E4419B-22A

**S E R V I C E N O T E**

E4419B - EPM Power Meter

**Power Meter Display Shrink**

**Figure 1**

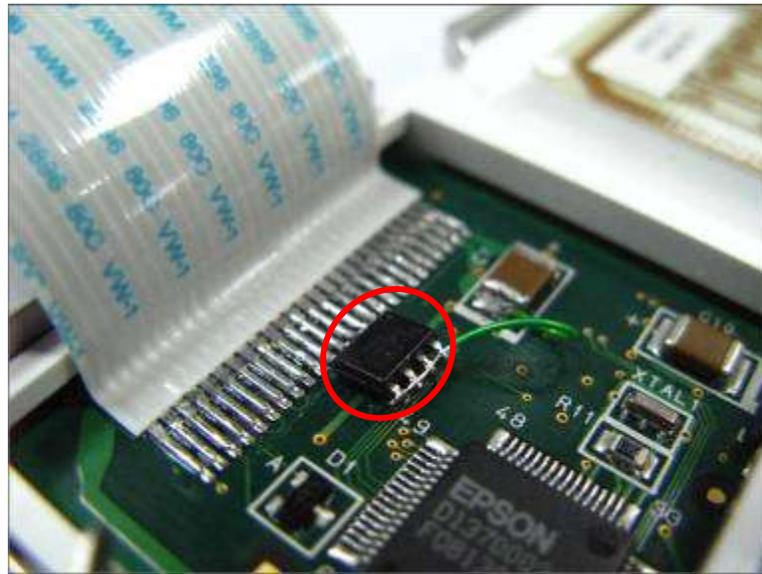
Due to some issues with the implementation of new LCD display controller in the power meter's display, intermittent display shrink is observed when operating the power meter. This however doesn't impact all the units. The display shrink scenario may look like something shown below:

To resolve this problem, replace the front panel assembly with a good one. A good front panel has additional Transient Voltage Suppress (TVS) diode soldered on its PCA **OR** additional ribbon cable with Damping Resistors attached to it. The photos for good front panel assembly are shown below. Additional of TVS diode **OR** Damping Resistors will prevent the display shrink from happening.
